Accepted Drainage Proposal

**Proposed Temporary Open Storage of Construction Materials
and Machineries for a Period of 3 Years and Associated Filling of Land
in “Agriculture” Zone, Lot 356 (Part) in D.D. 87, Kong Nga Po, Sheung Shui
(Compliance with Approval Condition (a) for Planning Application No. A/NE-FTA/251)**

Response to Comment Table

Drainage Proposal - LAYOUT

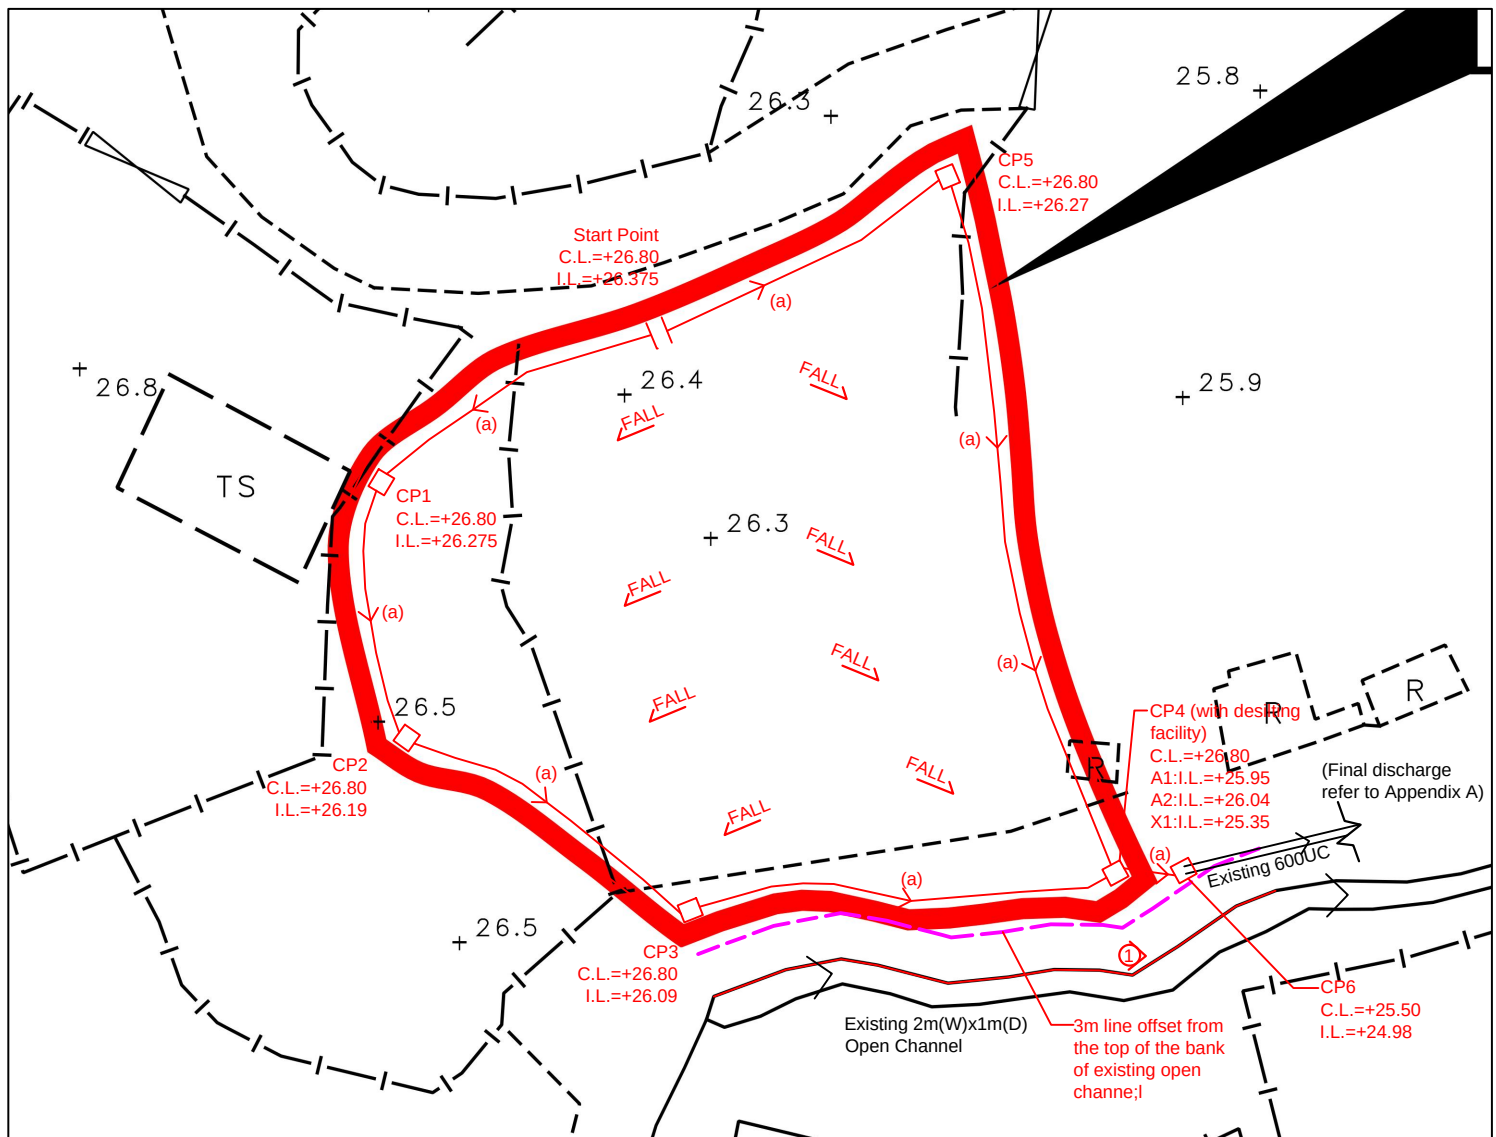
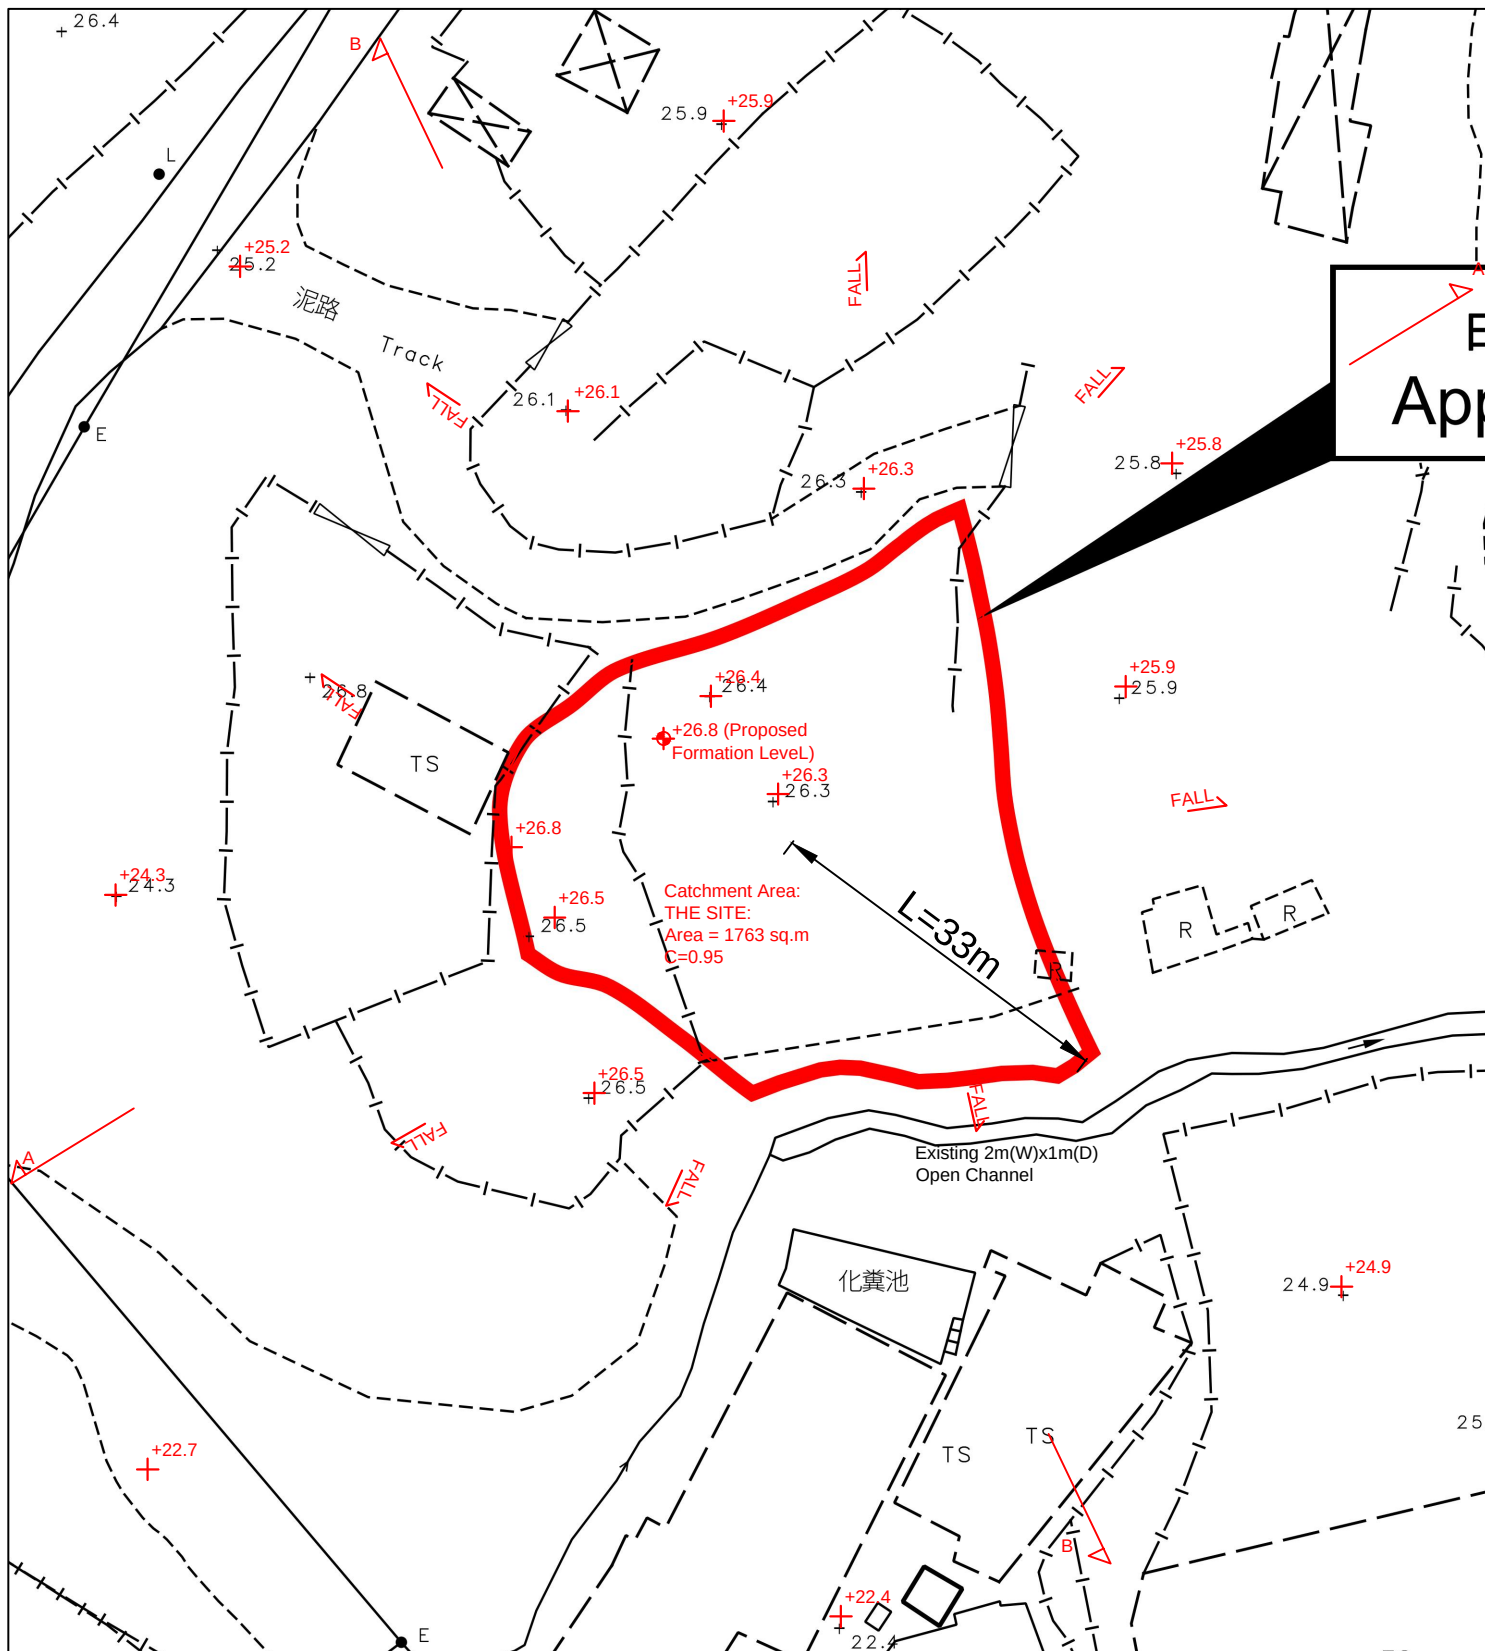
Comments from DSD	Response
The discharge path from CP4 directly to the existing streamcourse to the south is still indicated in the drainage plan, please review and clarify whether all surface runoff shall be discharged to the existing 600UC to the east.	The discharge path is revised, it should be discharged to the existing 600UC to the east
